September 11, 2018

Subject: DNR Initial Project Review
Project I.D. 1021-03-10/80
STH 93 Bridges B-18-0034, B-18-0119
Eau Claire County
T26N, R9W, Section 3

No.	Date	Revision	By
STATE OF WISCONSIN DEPARTMENT OF TRANSPORTATION DIVISION OF HIGHWAYS			
STRUCTURE B-18-119			
Const Spec	1981	Drawn By	Plans Checked
		R. J. G.	HOK
NORTH ABUTMENT		SHEET 5 OF 15 X82066

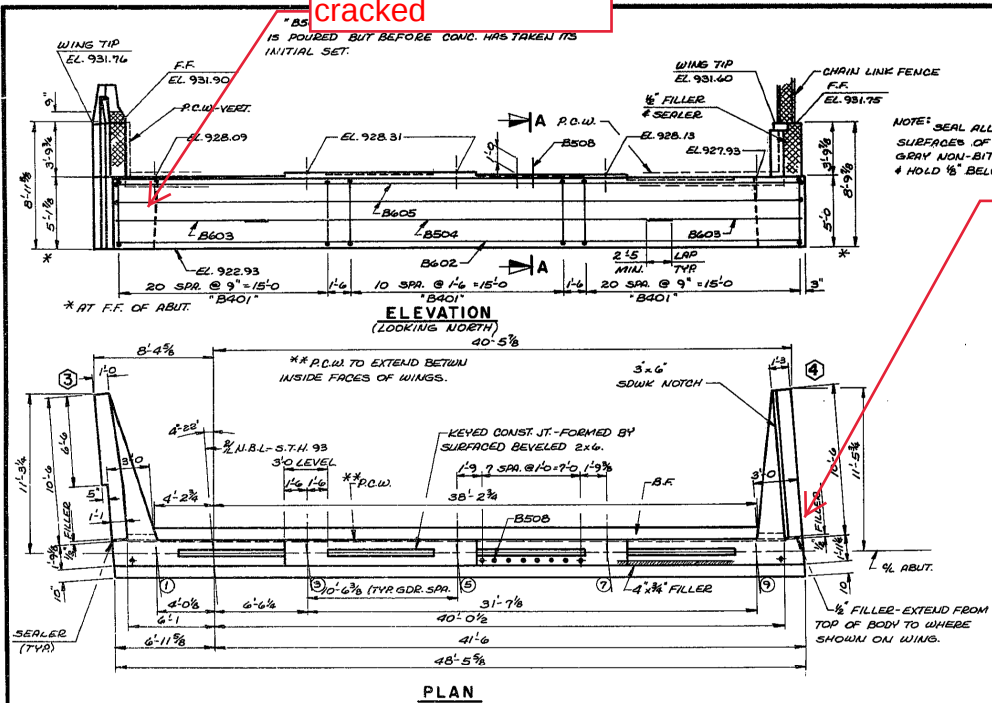
Abutment Backwall
cracked

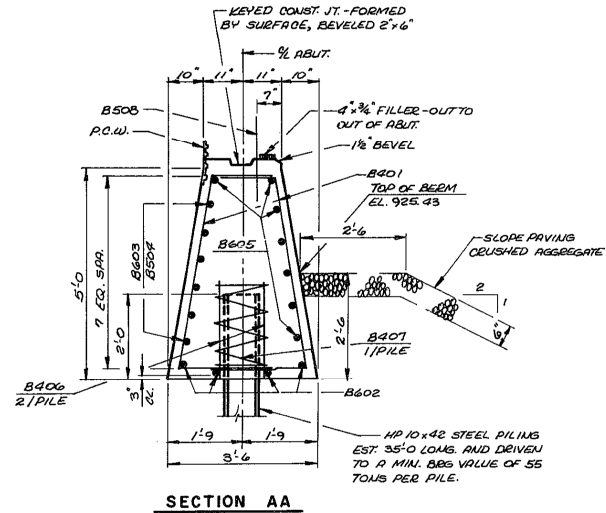
3.5'x1.5' Conc.
Surface repair on
wing wall

PIER 3

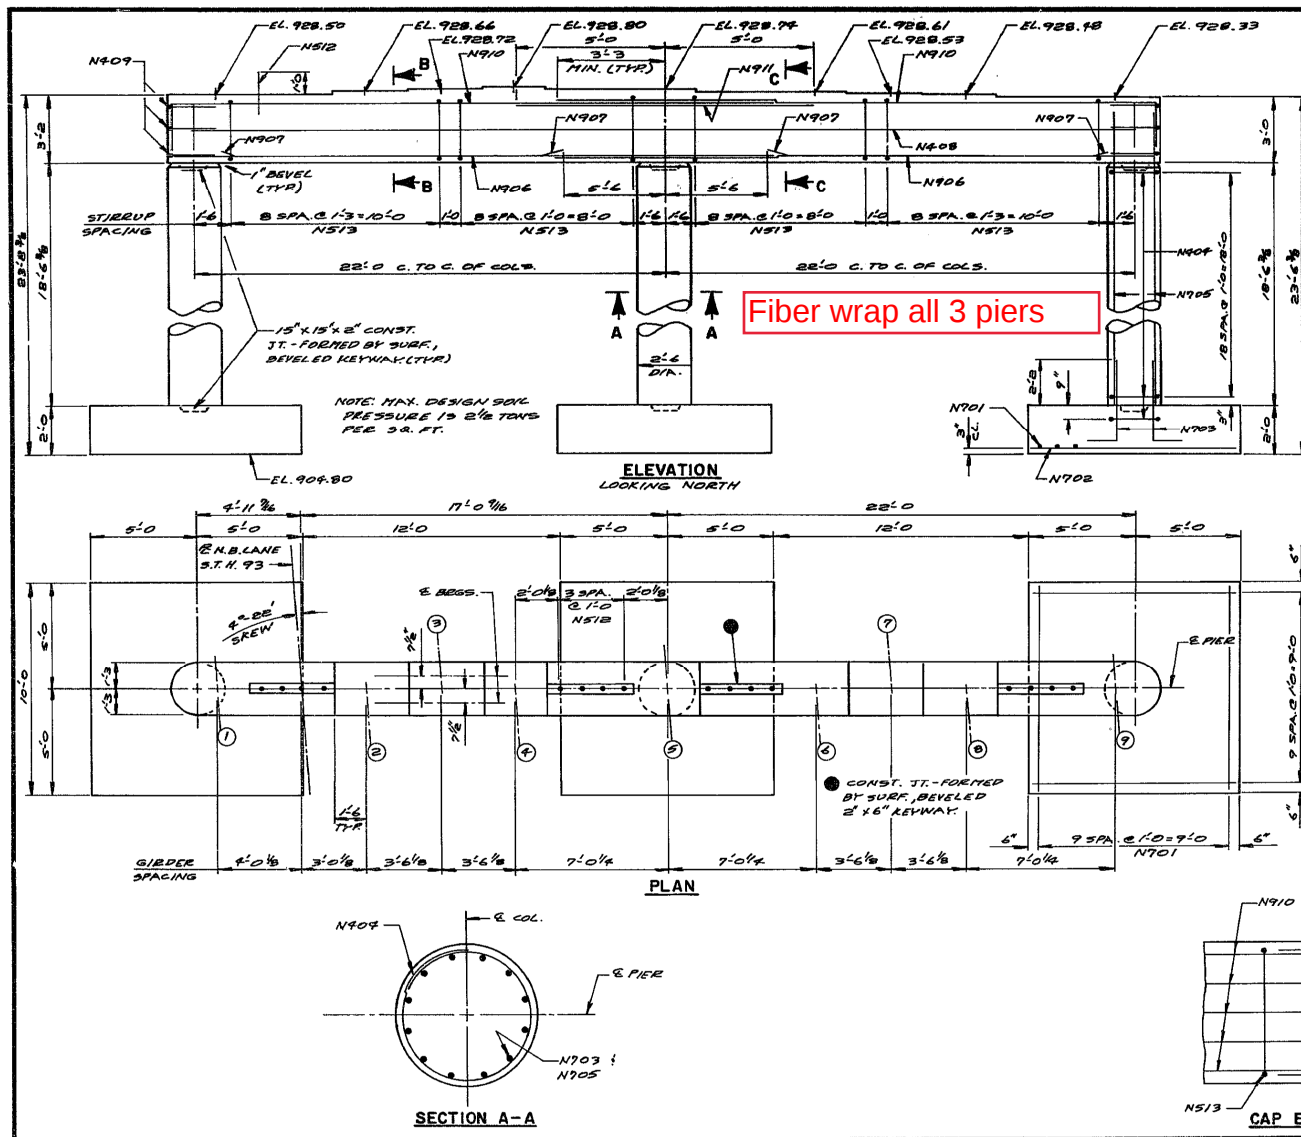
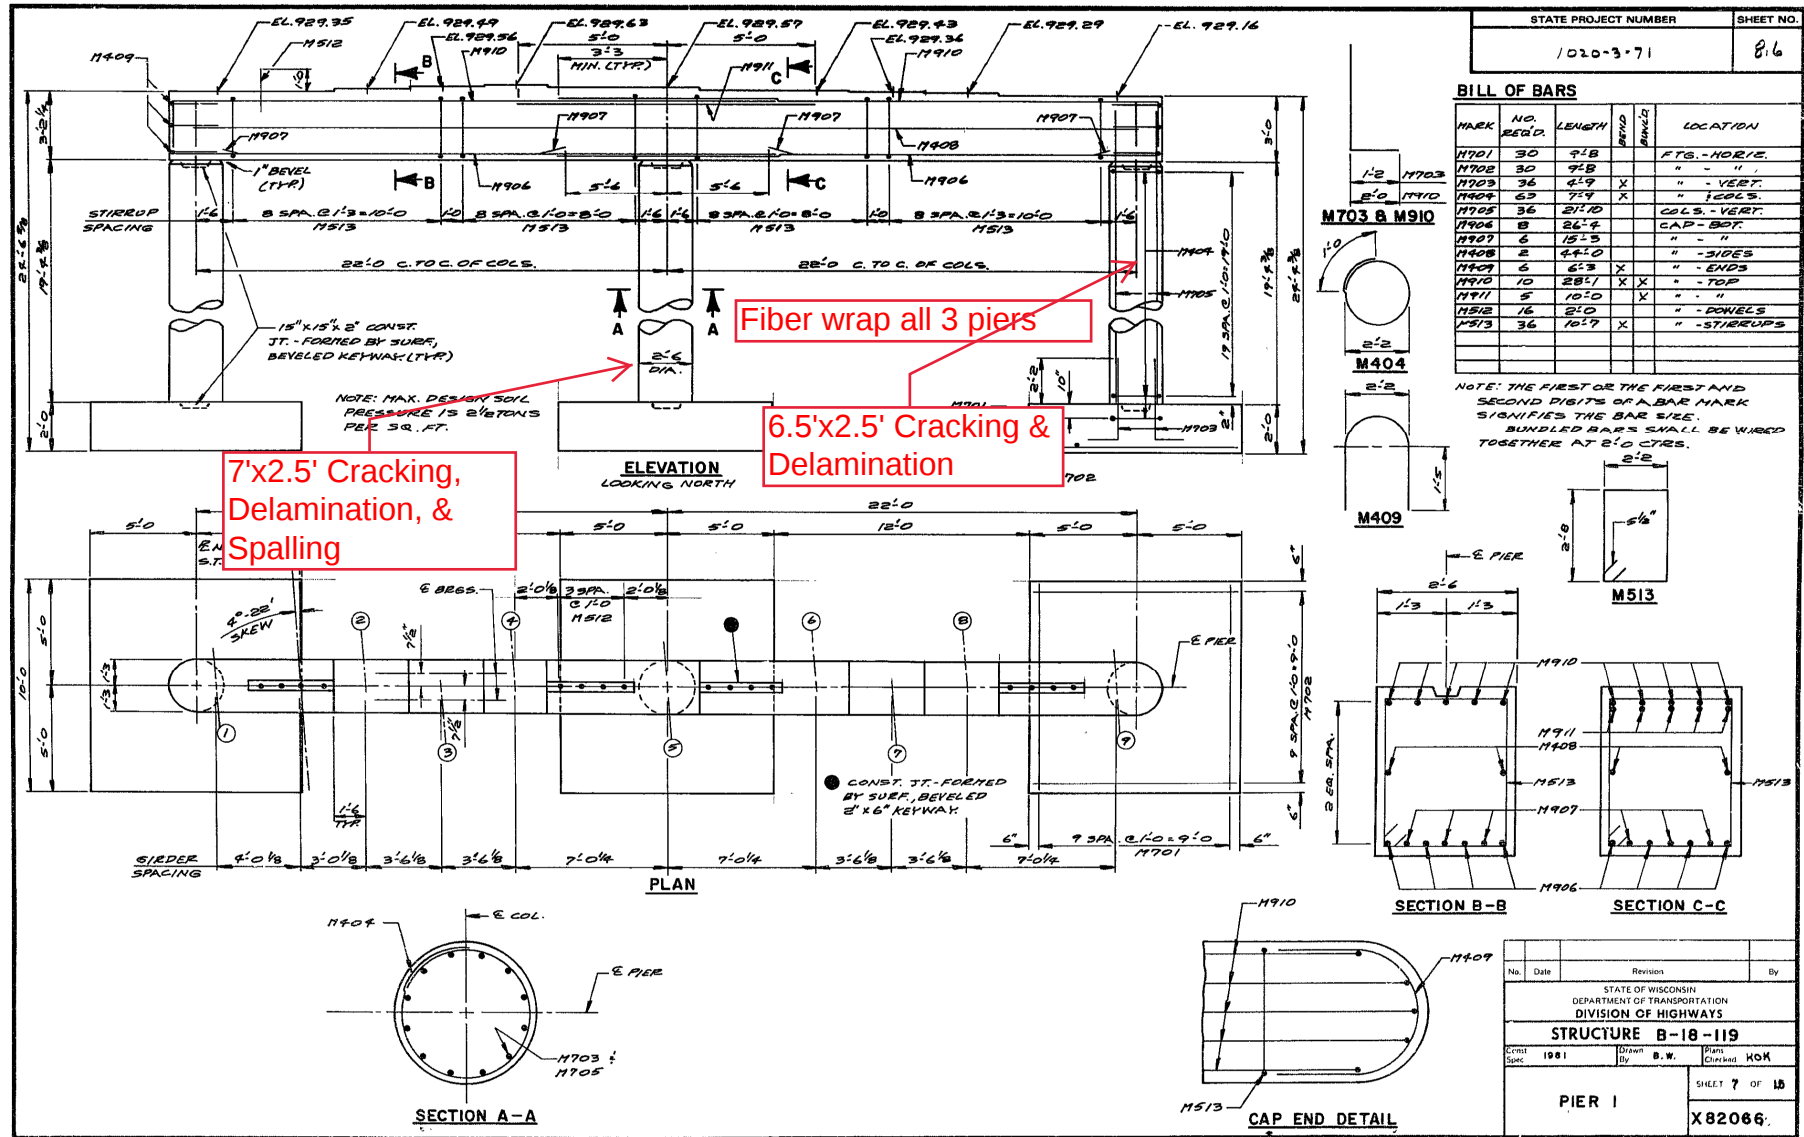
Fiber wrap all 3 piers
